Environmental Impact Statement Comment Summary and Response for Rosendale Dairy WPDES Permit

February 27, 2009

Figure 1
DNR January 2009 Dispersion Modeling Layout

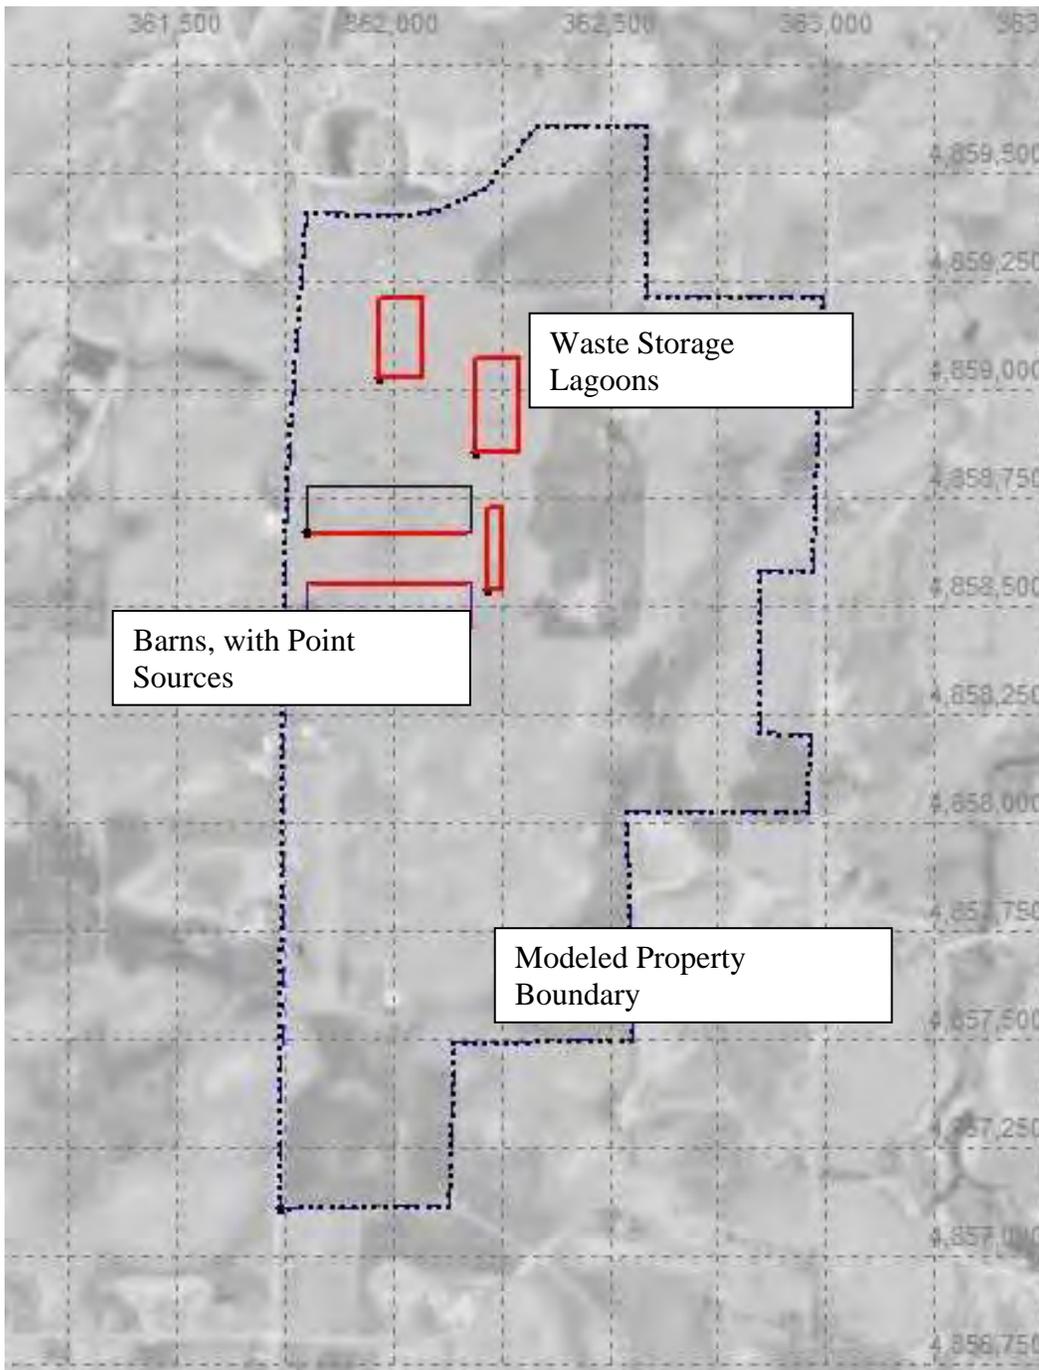
- Receptors were placed around the facility along the property boundary, as modified by the roadway network. Terrain elevations as derived from AERMAP were included. Please refer to Figure 1 for details.
